Checking of the cylinder head assy. (2/3) for ROTAX® Engine Type 912 and 914 (Series)

This ASB revises ASB-912-062/ASB-914-044 Revision 1

ATA System: 72-30-00 cylinder head

Fig. 1 spark plug

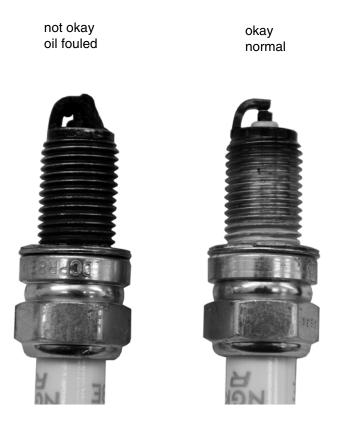
Unusual deposits (excessive carbon or oil) on the spark plugs are an indication of a defective cylinder head which must be replaced. Figure 1 shows comparison between a used spark plug in normal condition and one that is not.

Affected spark plugs with such deposits shown in chapter 4 Fig. 1, have to be removed and can not be reinstalled.

If excessive deposits (oil or carbon) are found on the spark plugs the cylinder head must be replaced in accordance with the relevant Maintenance Manual (Heavy) and any relevant aircraft manufacturer instructions.
